BOONE COUNTY, MISSOURI

Request for Bid #: 35-18JUL19 – Construction of Boone County Support Services Building

ADDENDUM #3 - Issued July 15, 2019

**ME1-1**

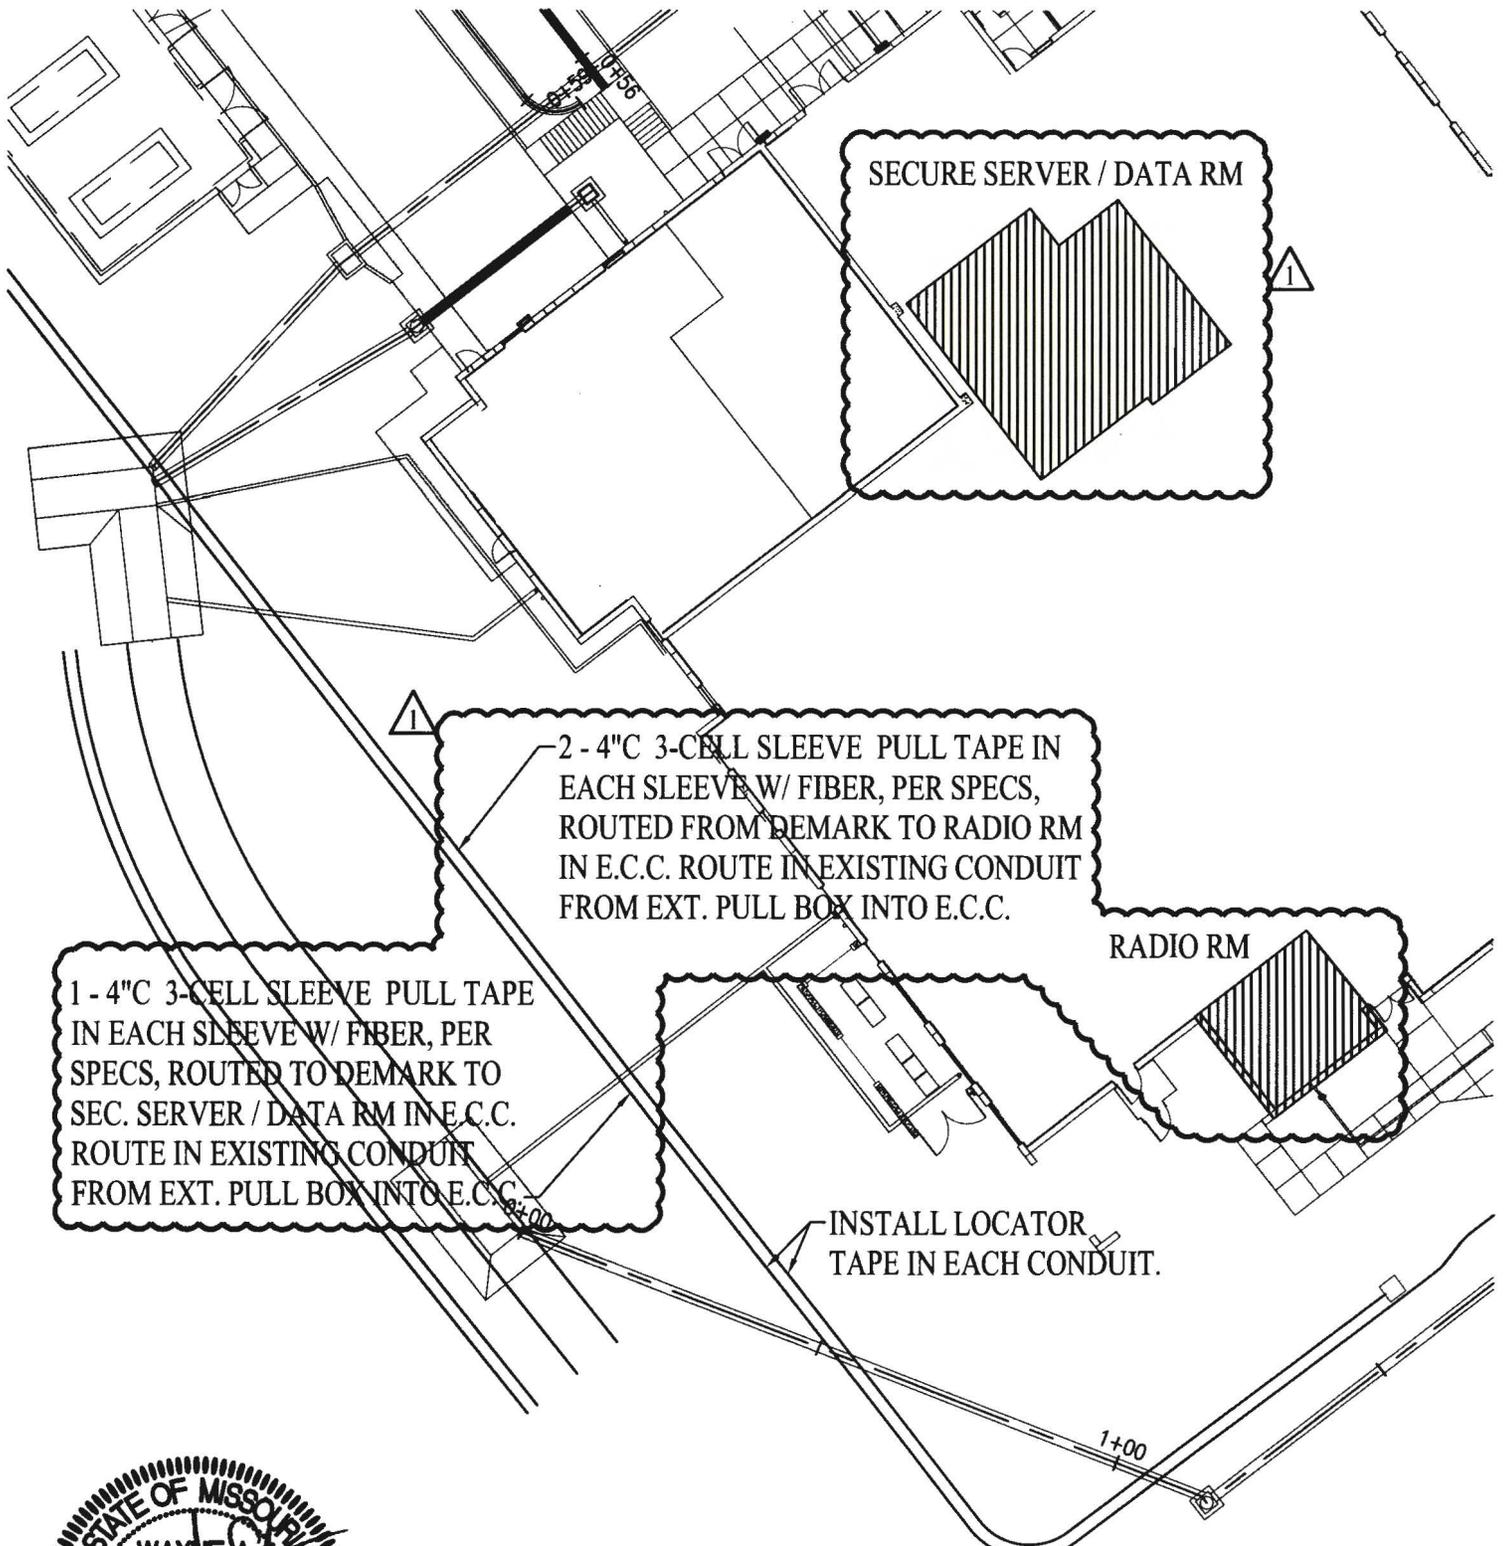
1. Drawing A601: The flooring type on the Room Finish Schedule for Room 102 Tech Office Evac Dispatch should be changed to be listed as carpet tile as indicated in the specifications.
2. Drawing ME1: See attached revised drawing ME1 for clarifications on fiber routing. The Lengths assumed for fiber routing from the external boxes to the East side of the building depicted on the drawings are as follows: 200 feet from the external pull box labeled on drawings to the Secure Server Data Room and 75 feet from the external pull box labeled on the drawings to the Radio Room. Should there remain excess fiber following these quantities then excess fiber will be left in the form of a service loop.
3. Drawing M4.1: Furnaces F-2, F-3, and F-4 are utilized in a downflow configuration.

2 - 4" C 3-CELL SLEEVE PULL TAPE IN EACH SLEEVE W/ FIBER, PER SPECS, ROUTED FROM DEMARK TO RADIO RM IN E.C.C. ROUTE IN EXISTING CONDUIT FROM EXT. PULL BOX INTO E.C.C.

1 - 4" C 3-CELL SLEEVE PULL TAPE IN EACH SLEEVE W/ FIBER, PER SPECS, ROUTED TO DEMARK TO SEC. SERVER / DATA RM IN E.C.C. ROUTE IN EXISTING CONDUIT FROM EXT. PULL BOX INTO E.C.C.

INSTALL LOCATOR TAPE IN EACH CONDUIT.
